ADDENDUM #6

Snowden Admin Building Mechanical Upgrades Project No. ANC-C-23-0001

Date: November 30, 2022

Sheet Number A901

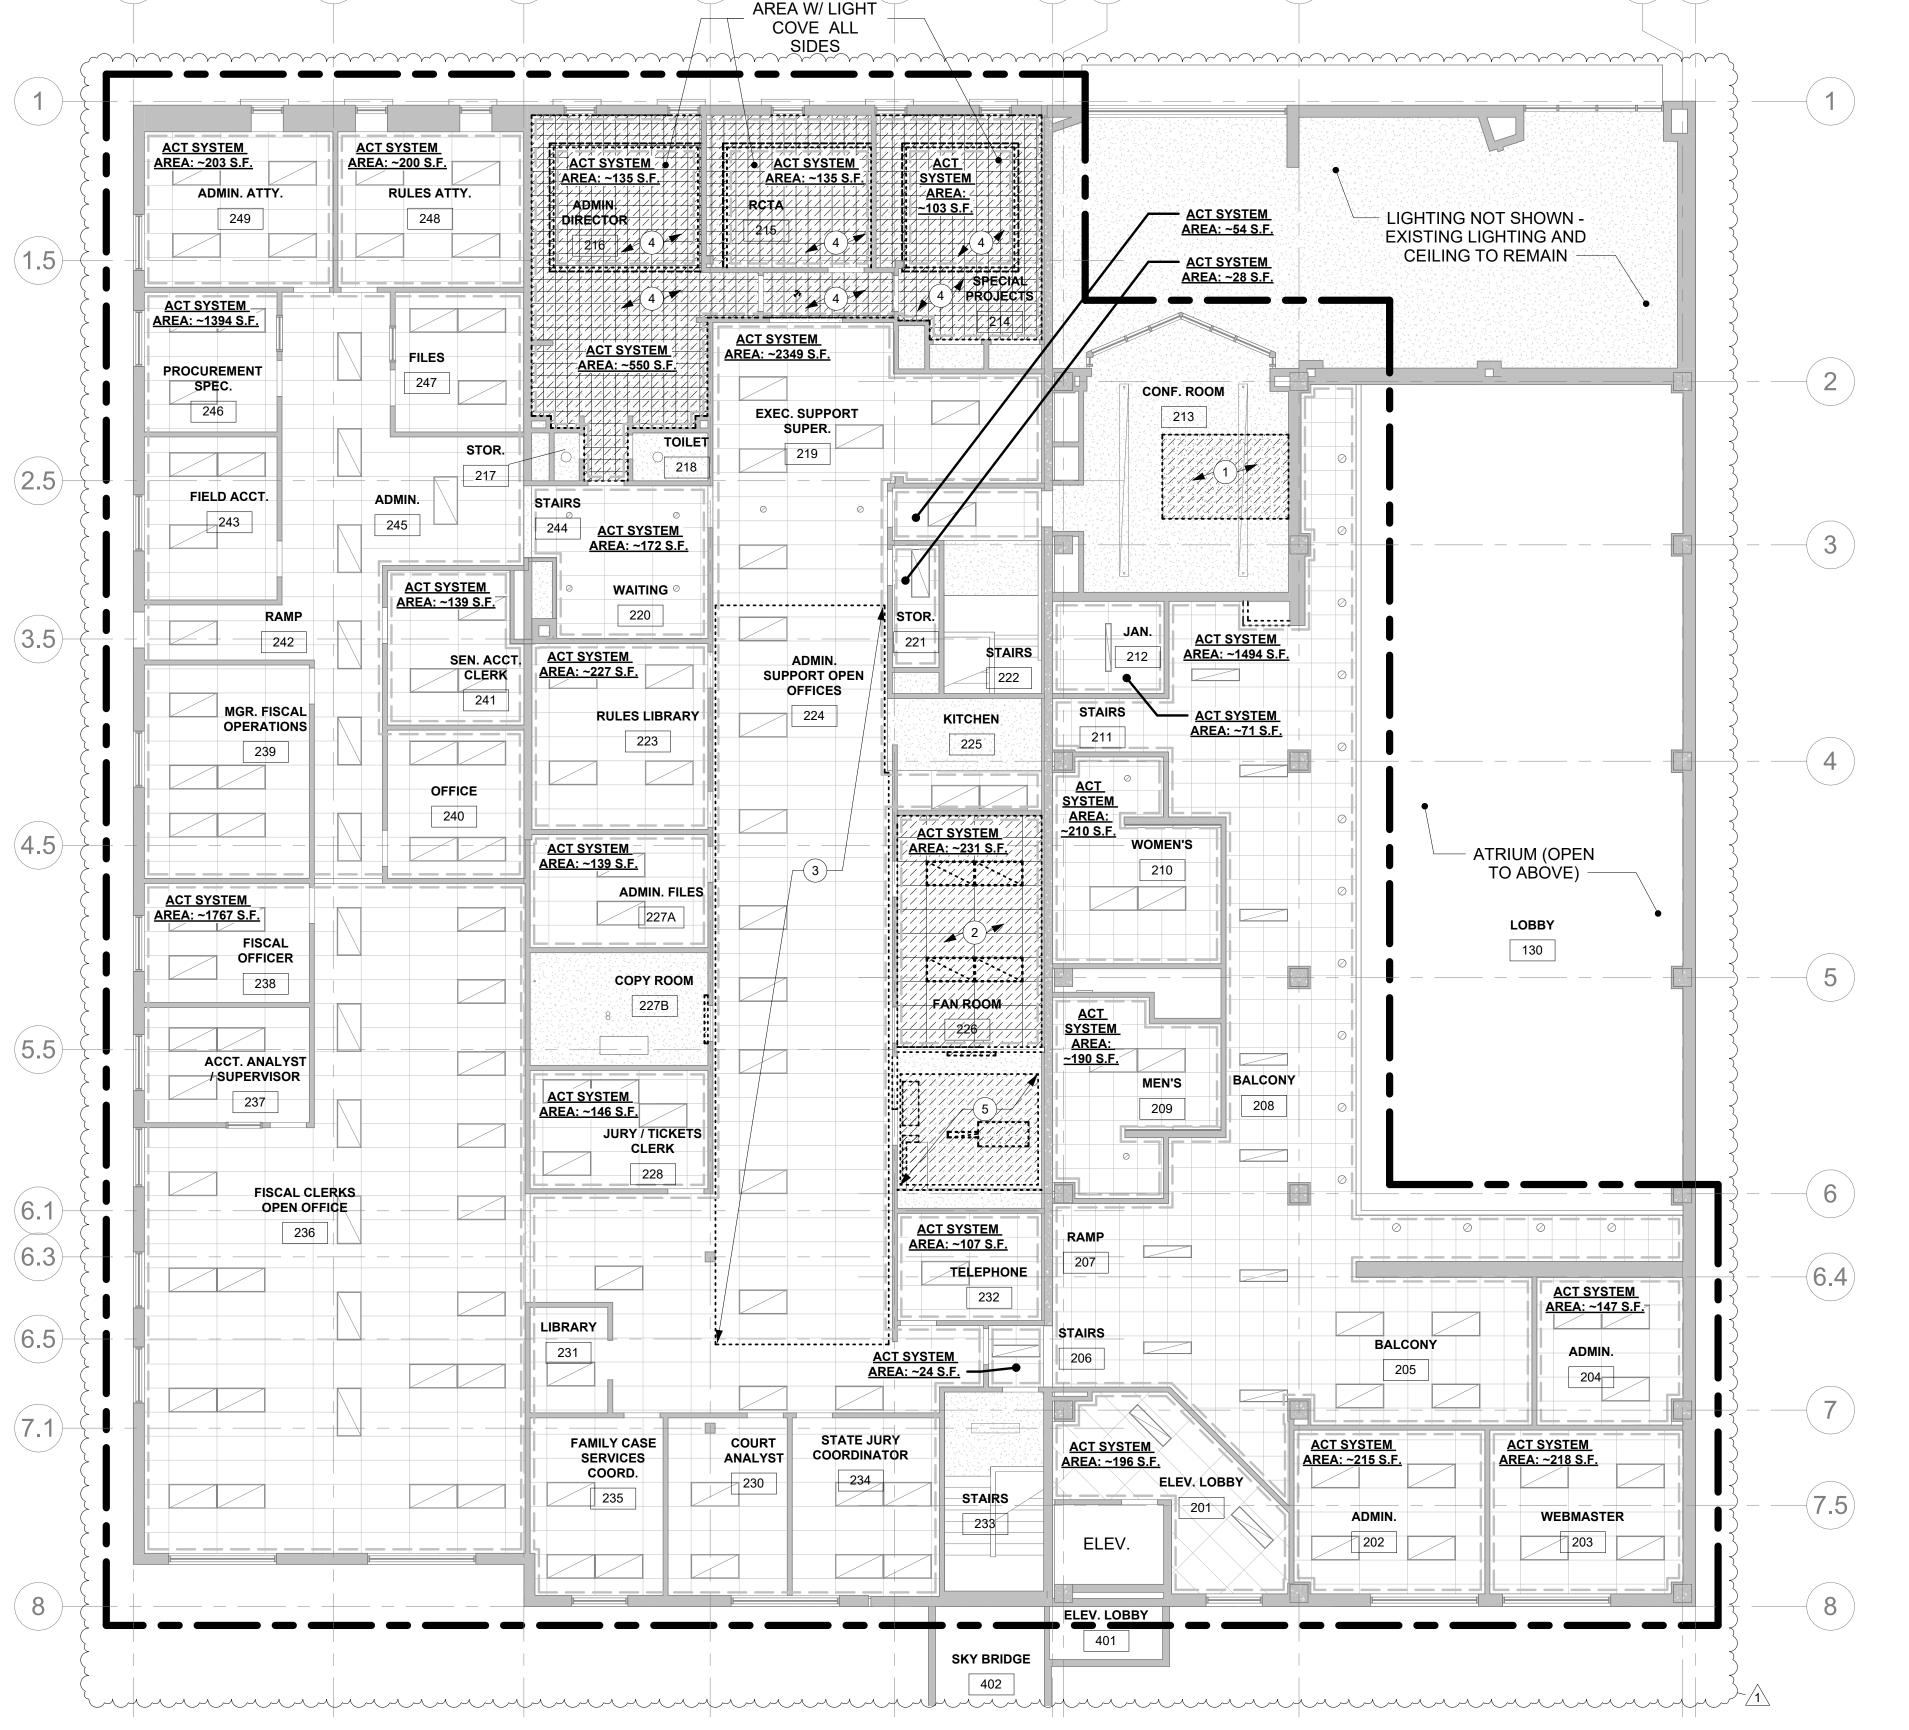
10) RCP General Note 1 on Sheets A901, A902, A903, A904, A905, and A906 states: "REPLACE ANY TILES THAT ARE REMOVED AND HAVE EXISTING DAMAGE AS WELL AS ANY TILES THAT ARE DAMAGED IN THE COURSE OF THE WORK. WHERE 50% OR MORE OF THE TILES ARE REMOVED IN CEILINGS OVER 144 SF, THE CEILING MUST BE EVALUATED FOR COMPLIANCE WITH THE SEISMIC PROVISIONS OF ASCE 7. UPGRADE SEISMIC BRACING TO COMPLY WITH ASCE 7 AND THE REQUIREMENTS OF 2018 IEBC SECTION 302.8 AS LOCALLY AMENDED." In order to establish the basis of bid scope for all bidding contractors, please provide an approximate quantity of existing ceiling tiles having damage that must be replaced, the approximate quantity where 50% or more of the tiles are removed in ceilings over 144 SF, and the approximate quantity of how many SF of ceilings are anticipated to require upgraded seismic bracing. Please provide these approximate basis of bid quantities for the Base Bid and Alternate #1.

The attached revised sheets A901, A902, and A903 clarify the extent of existing ACT ceiling systems, which in many cases extend over existing partitions. The existing ACT ceilings were installed in 1997. Seismic bracing was installed at the time, but it is presumed that it does not satisfy all current requirements for ceiling bracing.

Approximately 3% of the existing ceiling tiles exhibit damage. The meaning of "Damage" shall include visible holes, cracks, abrasion, or stains exceeding ½" length or width on the exposed portion of the panel.

In the Base Bid, where ceiling demolition is not explicitly indicated in the drawings, the extent of ceiling removal, replacement, and seismic upgrades are dependent on contractor means and methods as needed to perform the work. The contractor must plan the extent of removal and apply the note accordingly.

In Additive Alternate #1, Note #1 of "REFLECTED CEILING PLAN GENERAL NOTES" would only apply where existing ceilings outside the outlined area of Additive Alternate #1 must be removed to perform the work.
